# P802.1Qdt Text Contribution

Lily Lv (Huawei)

March-2022

<<This amendment is based on IEEE Std 802.1Q-Rev-d1-02>>

**Figure 36-1—PFC peering**

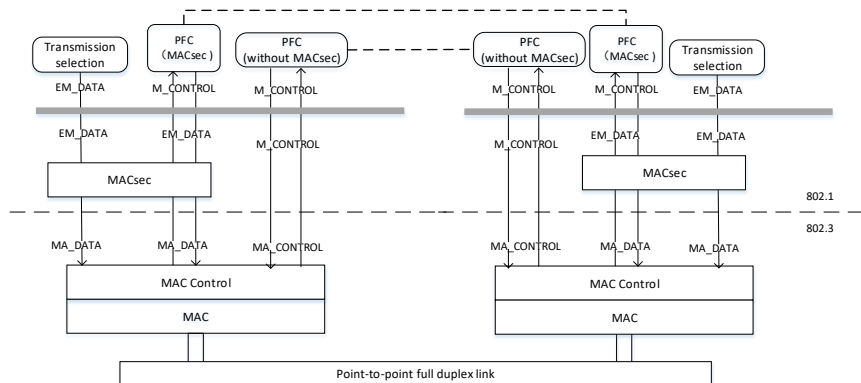
*Replace figure 36-1 with the following figure*
